Company	Trenz Electronic GmbH
PCN Number	PCN-20240619
Title	TE0715-05 SI5338 OTP Content Update
Subject	OTP Change
Issue Date	2024-07-22

2.1 #1 SI5338 OTP content update

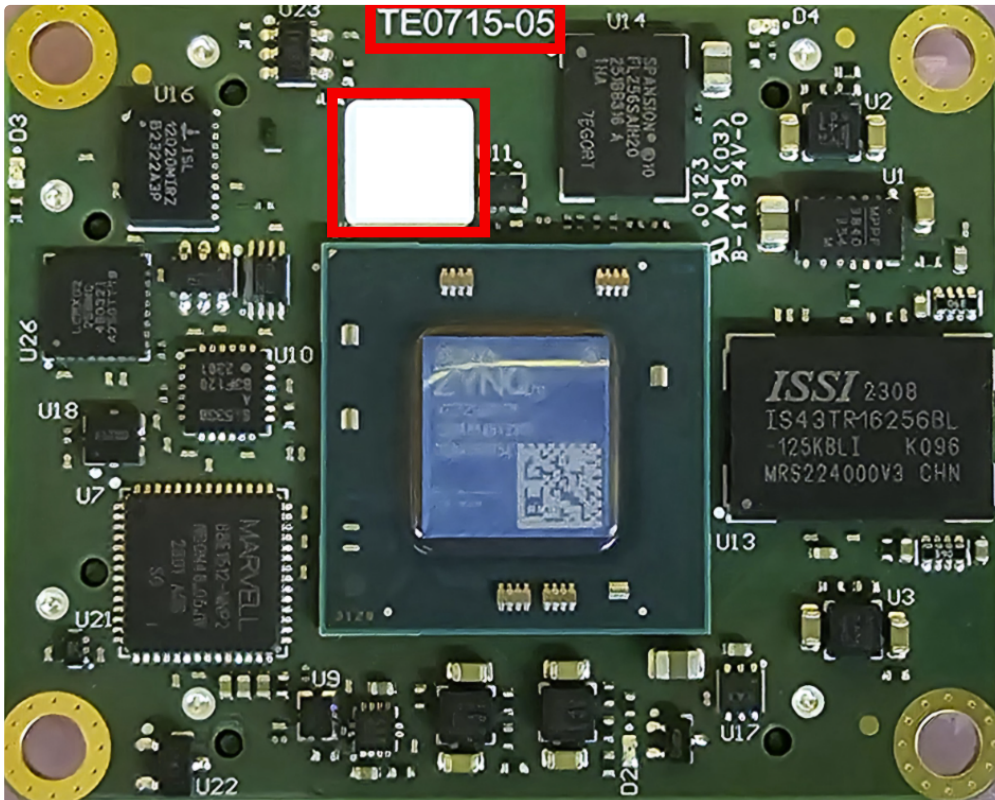
- a. New ClockBuilder Pro version (4.10) is used. This leads to parameter change # FDBK Mux = NoClk instead of # FDBK Mux = RefClk.
- b. Enable optional FPGA Fabric clock CLK2 125 MHz with LVDS18.
- c. Enable optional FPGA Fabric clock CLK3A 50 MHz with CMOS18.
- d. Set I2C voltage to 2.5V/3.3V instead of 1.8V

Reason: Improved PLL settings.

Impact: Additional clock is available on Bank 34 IO_L9N, Pin K2.
